## ON-SITE SEWAGE DISPOSAL SYSTEM HOWARD COUNTY HEALTH DEPARTMENT BUREAU OF ENVIRONMENTAL HEALTH

SITE INSPECTION SHEET

OWNER: Muller, Anna Mae PHONE #: \_\_\_\_\_  
 ADDRESS: LAWYERS HILL RD, # 6117 CONTRACTOR: TMR Improvements  
 \_\_\_\_\_ WELL TAG #: NONE; public H<sub>2</sub>O  
 SUBDIVISION: \_\_\_\_\_ LOT: \_\_\_\_\_ COUNTY #: \_\_\_\_\_  
 PROPOSAL: BP walk thru for replacing existing carport/  
garage. 600155858

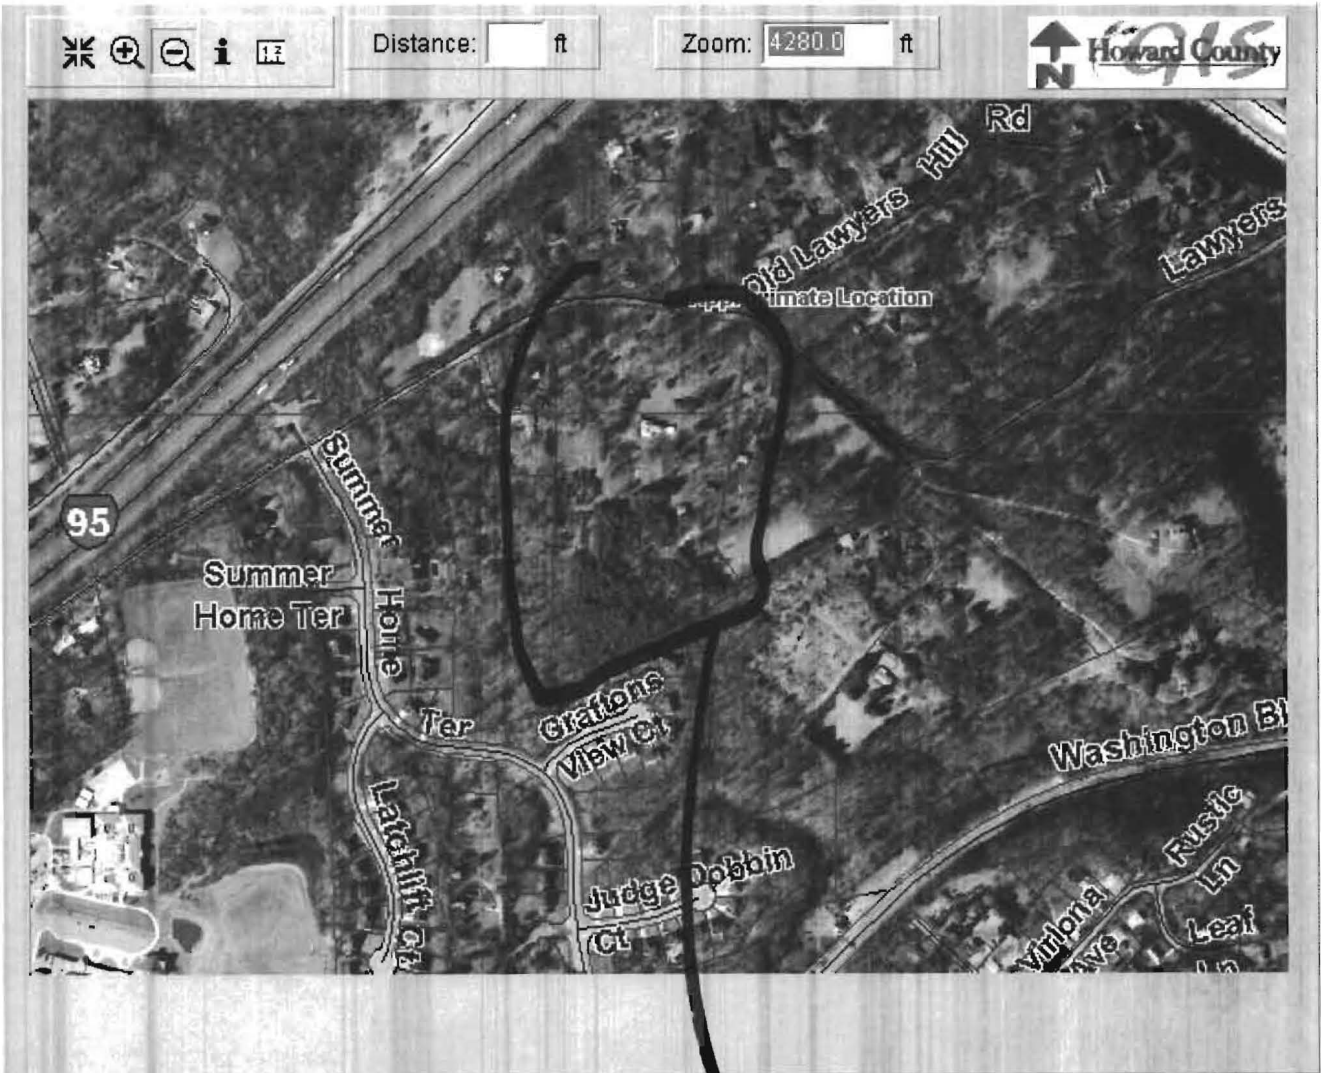
*9/1/05 septic Public water location  
 Effluent level below PVC pipe ~ 4'-4 1/2'. Told contractors system may have only few years left*
